<p>Independent Assessment Report (Planning Ingenuity)</p>
--

Development Application: 94-104 Epsom Road, Zetland - D/2019/976**File No.:** D/2019/976**Summary**

Figure 37 Material palette from the design competition and current proposal.

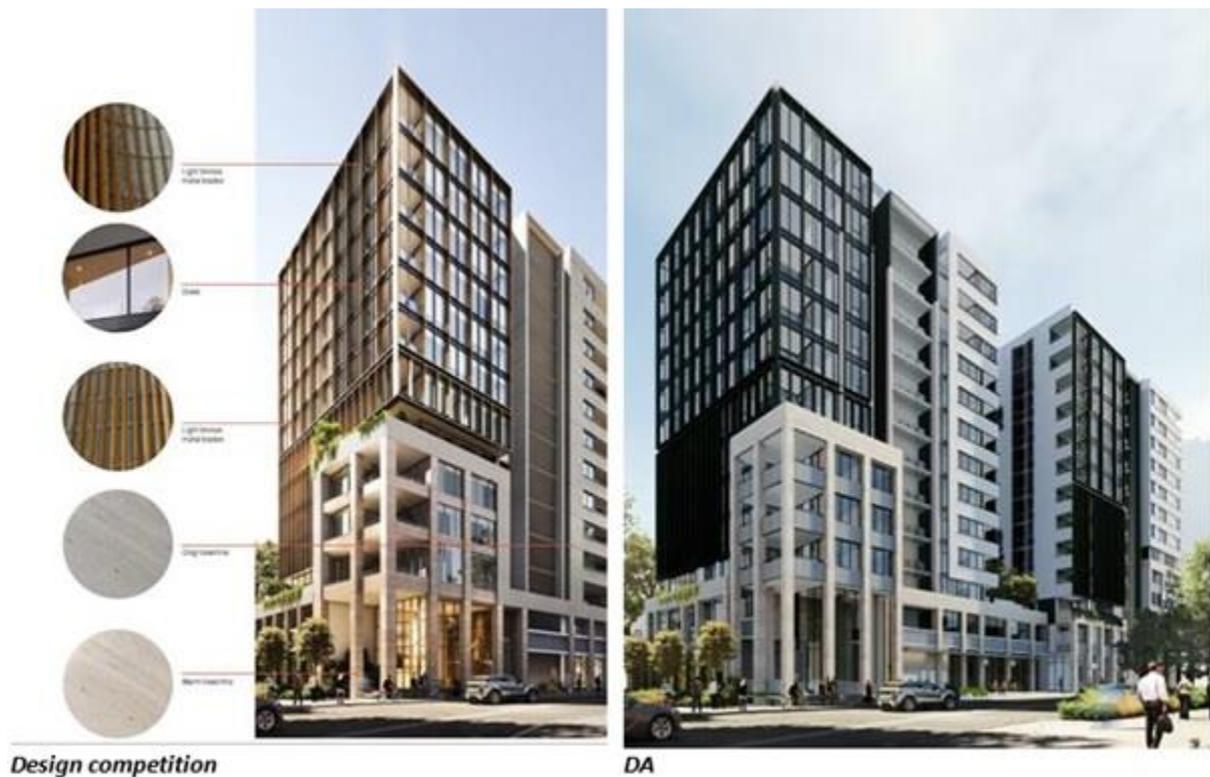
- a) whether a high standard of architectural design, materials and detailing appropriate to the building type and location will be achieved;

Comment: The development achieves a high standard of architectural design, being of a scale, form and design that is consistent with the desired future character of the Epsom Park locality and compatible with other developments in the streetscape. Furthermore, the development is generally consistent with the design scheme selected as winner of the competitive design process, other than the proposed use of external materials and colour palette, as detailed in Figure 9 below. The materials and colours of the competitive design process winning scheme are 'warmer' and provide a more natural palette, which is considered to be exemplary to the proposal. As such, conditions of consent will require materials to be provided in accordance with those presented as part of the competitive design process winning scheme.

Figure 41 Height blanket diagram showing areas of non-compliance with the LEP maximum heights

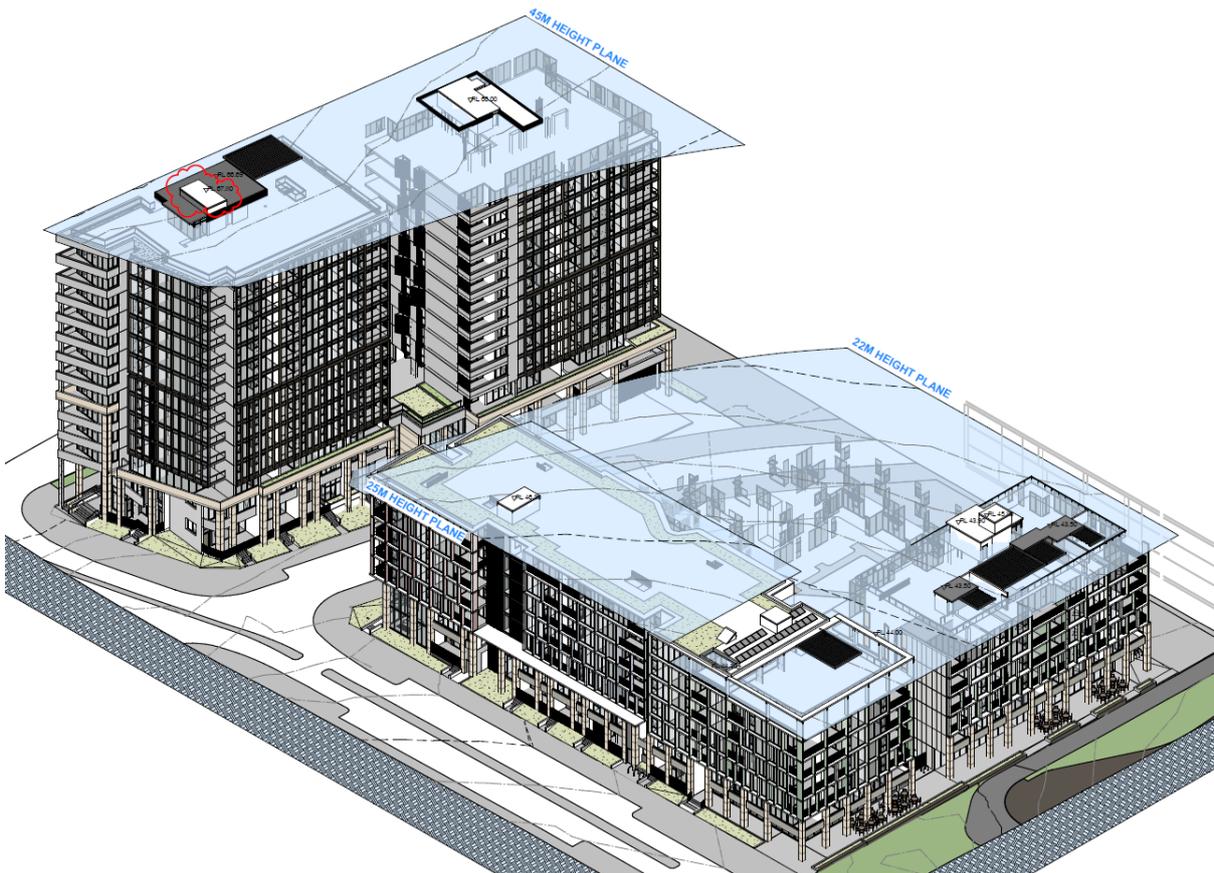
184. The proposed development exceeds the prescribed building heights as follows:
- 23m (RL 45.80) is proposed for Building A on the northern side of the site, which exceeds the 22m height limit by a maximum of 1m (4.5%).
 - 25.5m (RL 46.30) is proposed for Building A on the eastern side of the site, which exceeds the 25m height limit by a maximum of 0.5m (2%).
 - 46.5m (RL 67.80) is proposed for Building C in the southern parcel, exceeding the 45m height limit by a maximum of 1.5m (3.3%).

185. Therefore, the maximum non-compliance ranges from 0.5-1.5m, equating to a variation of between 2% and 4.5%.

Figure 43: Extract of Building C Level 7 floor plan, illustrating various privacy treatments incorporated into the design

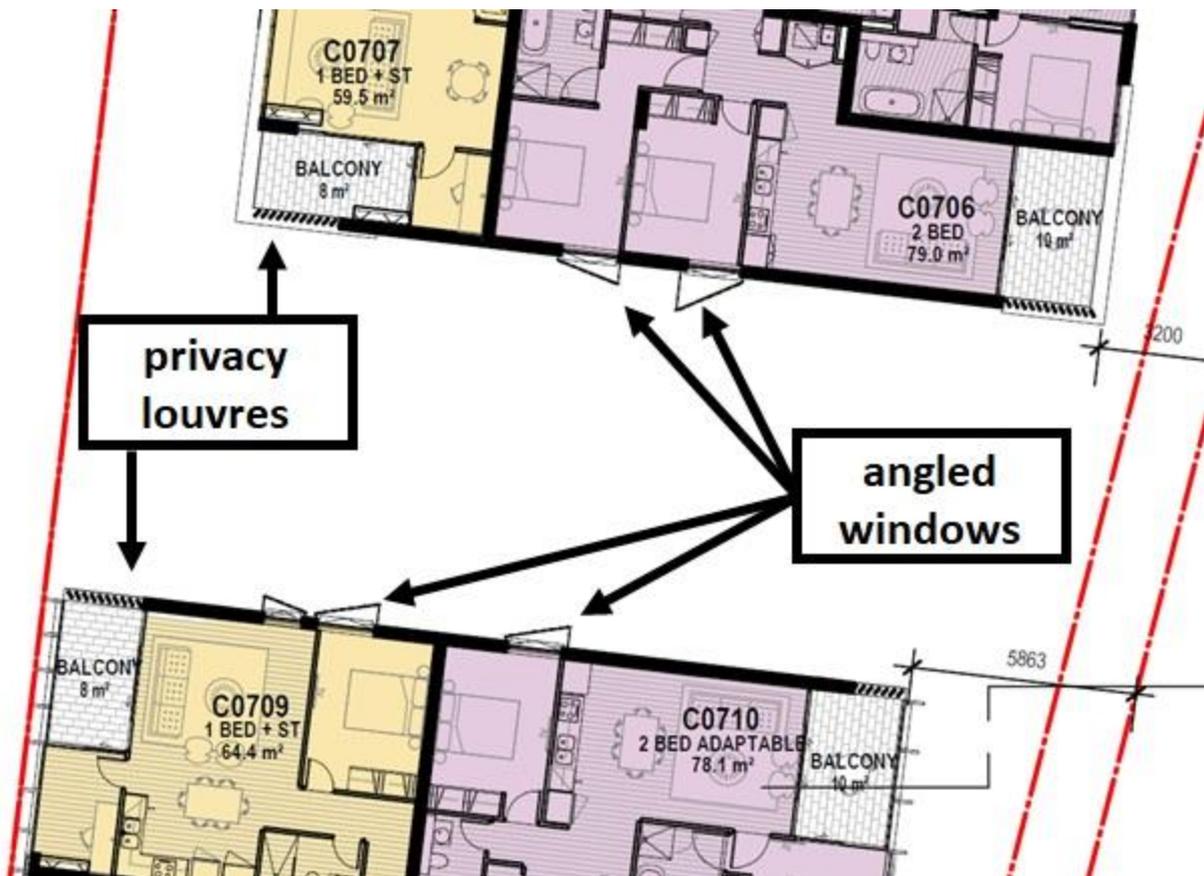
229. Building C contains a separation between residential towers of 10.2m on Levels 3 – 13. This provides a numerical non-compliance with the distances prescribed by the ADG of 1.8m (Level 3), 7.8m (Levels 4 to 7) and 13.8m (Levels 8 to 13), respectively.

230. It is noted that the objective of this part of the ADG (3F-1) is to ensure that apartments achieve reasonable levels of visual privacy. To ensure that acceptable levels of visual privacy are provided for all affected apartments within Buildings A and C, a number of privacy treatments have been incorporated into the design of the buildings. This includes the use of privacy louvres and angled 'pop-out' windows to limit any direct views between habitable rooms.

231. The above treatments are considered to mitigate any potential adverse visual privacy impacts for proposed apartments. Similar treatments are proposed for apartments facing each other in Building A. However, apartments on Levels 4 - 7 (A0406, A0506 and A0605) have east-facing windows serving kitchen/dining areas which do not appear to have any privacy treatments. This will face directly onto west-facing open balconies for apartments on the opposite side of the through site link.

Figure 44: Level 5 floor plan, showing non-treated windows outlined in red.

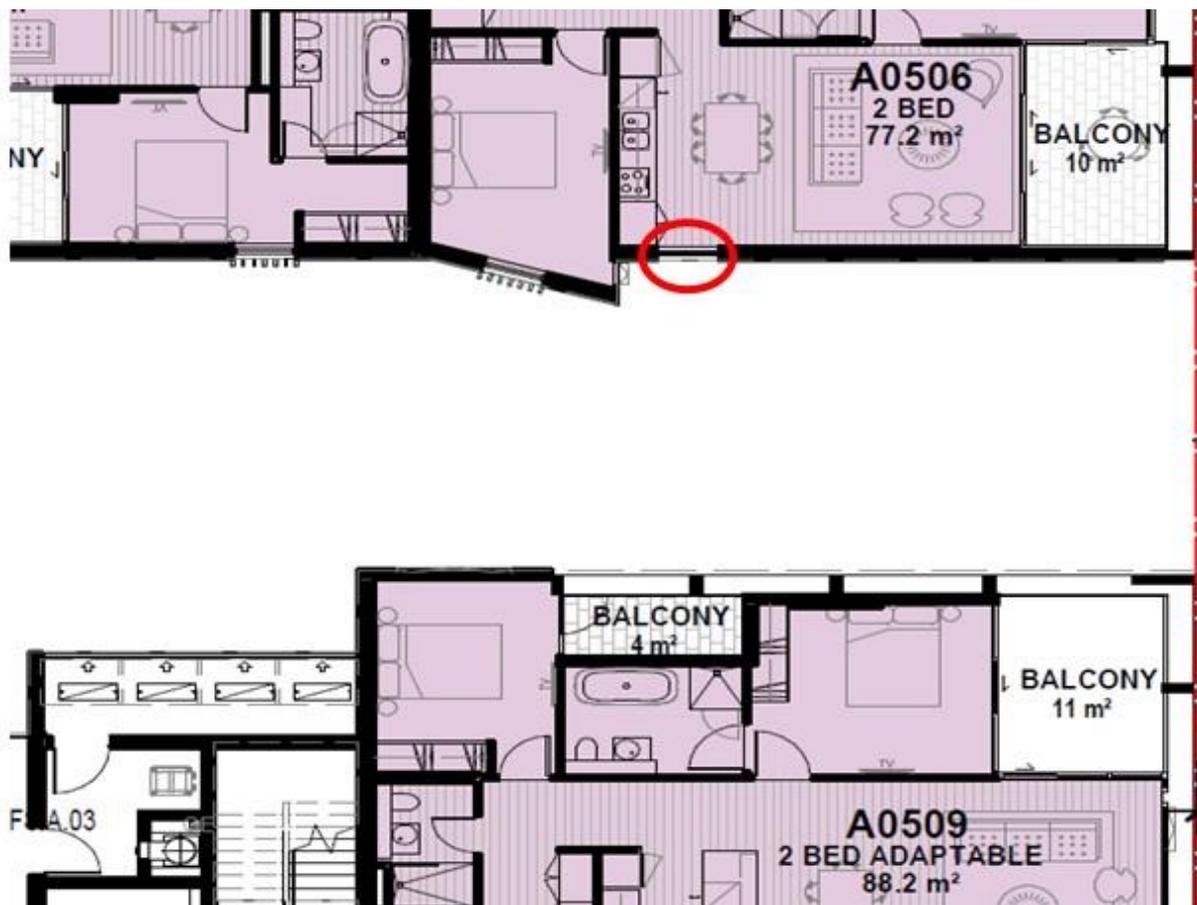
232. Conditions are recommended requiring design modifications for suitable privacy louvres to be incorporated into the design of these units as shown in the example extract in Figure 34 below.

Figure 4: Proposed location and design of acoustic treatments to Building C.

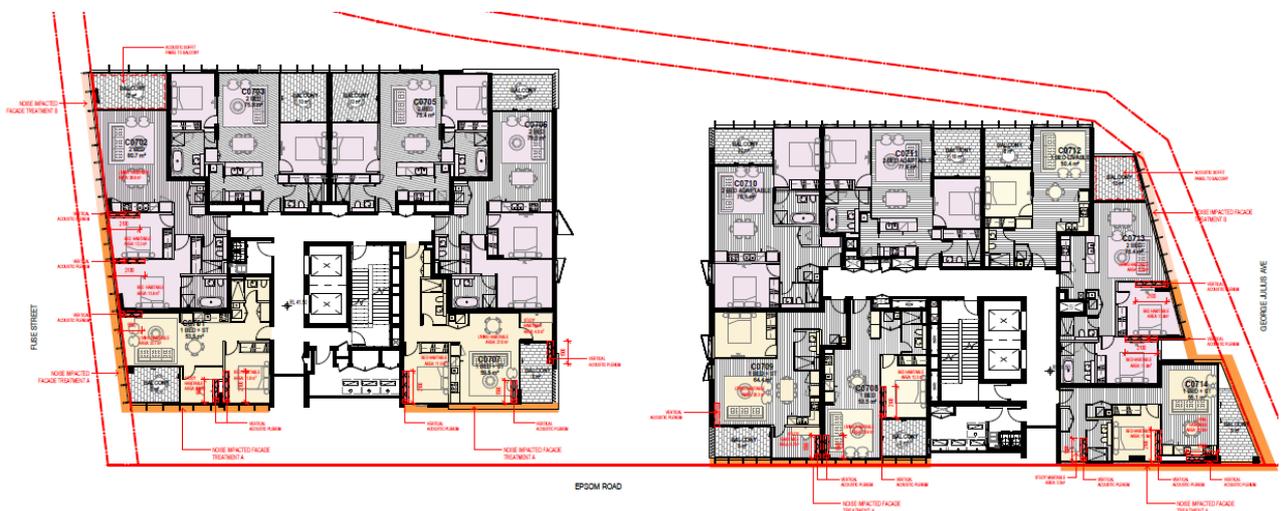
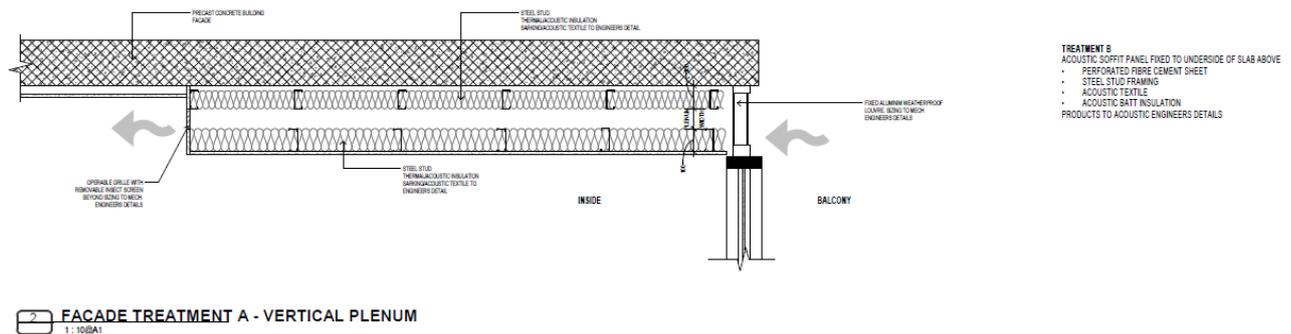
240. The acoustic assessment report submitted with the application indicates that the bedrooms and living areas of all apartments of Building C that face Epsom Road do not achieve DCP noise criteria with windows open to achieve natural ventilation. The proposed development seeks an alternative design in the form of an acoustic plenum that will be incorporated into the design of each affected bedroom and living room to ensure that satisfactory acoustic privacy and natural ventilation are achieved.

241. The plans and section below provide an indication of where the acoustic plenums will be located and how they will be designed.

242. Council's Environment Health Officer has assessed the proposal and acknowledges that the design has the capability to accommodate such an arrangement to ensure that each apartment is naturally ventilated whilst still achieving internal acoustic compliance as per the ADG and SDCP 2012.
243. To ensure this is provided whilst not adversely impacting the external appearance of the proposed building or the internal amenity of the proposed apartments, conditions of consent will require further design detail and verification of the proposed acoustic plenum arrangement or an alternative solution to be provided prior to construction certificate. This will include a requirement to have the design verified by a ventilation expert.

Figure 5: Proposed floor plan for A0209 (left) and plan showing location of required window for cross ventilation (right).

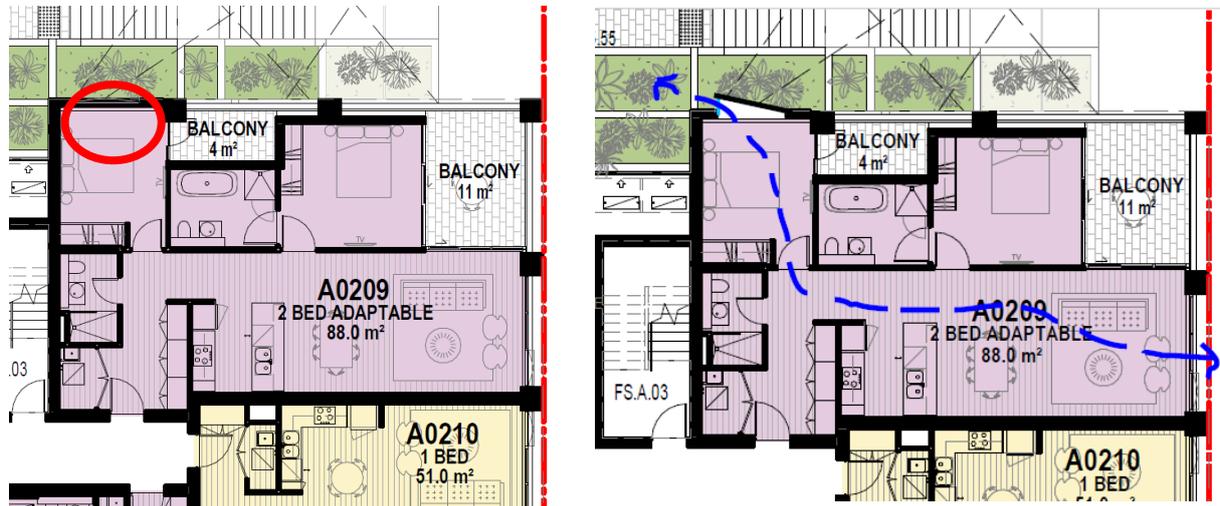
248. A number of corner apartments within Building A are required to incorporate a window within bedrooms to achieve cross ventilation. As such, conditions of consent will require a number of apartments (A0201, A0209, A0309, A0409, A0509, and A0608) to incorporate amended window design to provide openable 'pop-out' windows and thus adequately achieve natural cross ventilation whilst maintaining privacy. An example of this is provided for apartment A0209 below.

Furthermore, a number of apartments in Building A are provided with skylights for cross ventilation (A0603, A0701, A0702, A0704, A0706, and A0709). The skylights have not been located deep enough within the floor plate of these apartments to ensure adequate cross ventilation. As such, conditions of consent will require these skylights to be relocated accordingly.
